DOCUMENT CHANGE REQUEST

DCR number 549	Changes required for: General	Originator: Steve Thacker - ESCC
Date: 2009/10/07	Date sent: 2009/10/07	Organisation:
Status: IMPLEMENTED

Title:	Resistor Fixed Surface Mount Thin Film Non Hermetically Sealed,		
Number:	4001/029	Issue:	1

ESCC Detail Specification No. 4001/029

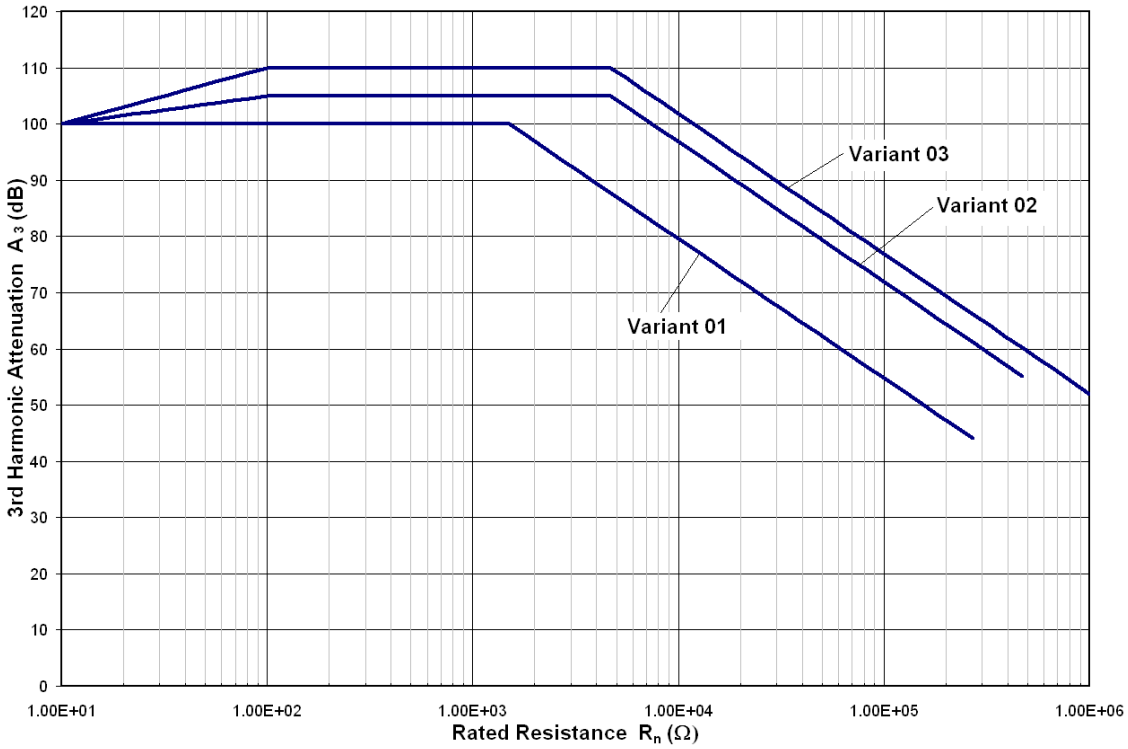
8. Table 2, Insulation Resistance test is added with note 3 stating guaranteed but not tested, to be consistent with new Para 2.6 (in new Para 2.5.1).

Characteristics	Symbols	ESCC 4001 Test Method and Conditions	Tolerance (± %)	Limits		Units
				Min	Max	
Resistance	R_A	Para. 8.3.1.1	0.1	0.999 R_n	1.001 R_n	Ω
			0.5	0.995 R_n	1.005 R_n	
			1	0.99 R_n	1.01 R_n	
3rd Harmonic Attenuation	A_3	IEC Publication No. 60440 Note 1	All	Note 2	-	dB
Insulation Resistance	R_I	Para. 8.3.1.2 V=100V Note 3	All	1000	-	MΩ

3. Guaranteed but not tested during Screening Tests.
